86100C-12A

S E R V I C E N O T E

86100C Digital Communications Analyzer Mainframe

Motherboard board mounting modification improves product reliability related to boot up issues.

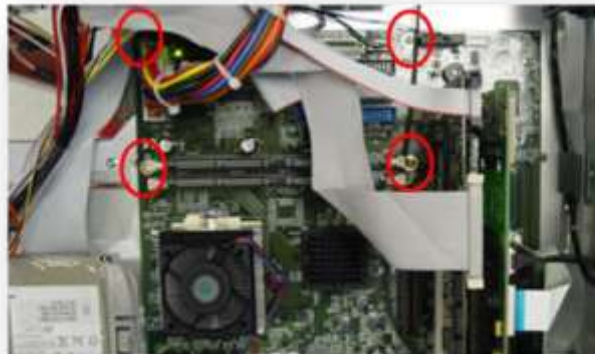
The most common symptom is a boot up error as shown here. The mainframe will come to the point where all LEDs are lighted but will not progress through the boot sequence.

This can be either a hard failure or very intermittent.

To verify the problem is related to the board flexing issue:

1. Power the instrument off and remove the cover.
2. Loosen the four screws indicated here.
3. Re-boot the instrument.
4. If it boots normally, then board flex caused by the foam is a likely cause.
